Access Compliance Report

Public Rights-of-Way

(Curb Ramps)

Intersection ID: 6029	Main Street: PIMPERNEL_RD	Cross Street: ROSEMALLOW_RD	Location: NW
ADA ID: 37D359392FCB	Ramp Type: Perp	Initial Pass/Fail: Fail	Overall Compliance: No
Severity Score: 25			
Codes/Mitigation Info/Possible Solution		Field Measurements/Component Compliance

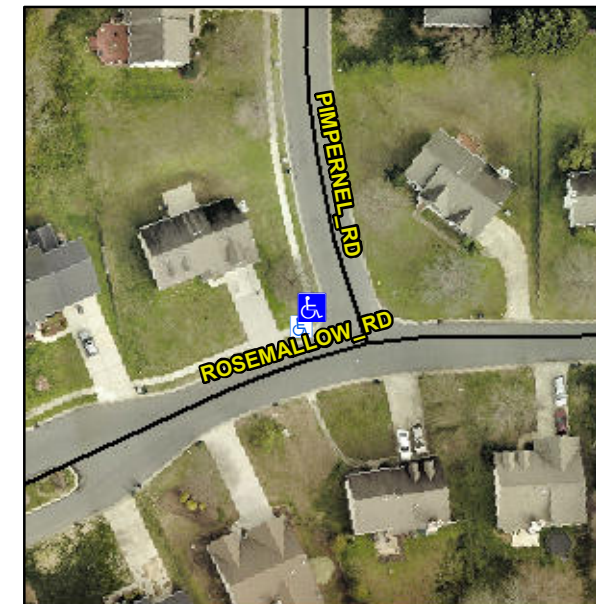
Not Found, R304.5.3

Compliance	Description	Data	Compliance	Description	Data
N/A	Ramp Length (in)	45.5	Yes	Ramp Slope (%)	5.2
Yes	Ramp Width (in)	48.0	No	Ramp XSlope (%)	8.2
N/A	Flare Type LT	N/A	N/A	Flare Type RT	N/A
N/A	Flare Slope LT (%)	N/A	N/A	Flare Slope RT (%)	N/A
N/A	Flare Traversable LT?	N/A	N/A	Flare Traversable RT?	N/A
N/A	Landing Length (in)	N/A	N/A	DWS Provided?	N/A
N/A	Landing Width (in)	N/A	N/A	DWS Contrast?	N/A
N/A	Landing Slope (%)	N/A	N/A	DWS Length (in)	N/A
N/A	Landing X Slope (%)	N/A	N/A	DWS Full Width?	N/A
N/A	Landing Curb? (Y/N)	N/A	N/A	DWS Offset (in)	N/A
N/A	Shared Landing?	N/A			
N/A	Gutter Ponding?	N/A	N/A	Gutter Slope (%)	N/A
N/A	Gutter Lip Ht (in)	1.0	N/A	Gutter X Slope (%)	N/A
N/A	Painted X Walk1?	No	N/A	Painted X Walk2?	N/A
	X Walk 1 Direction	To E		X Walk 2 Direction	N/A
N/A	X Walk 1 Width (in)	N/A	N/A	X Walk 2 Width (in)	N/A
	X Walk 1 Slope (%)	9.7		X Walk 2 Slope (%)	N/A
	X Walk 1 X Slope (%)	5.2		X Walk 2 X Slope (%)	N/A

Remove & Replace Entire Ramp.
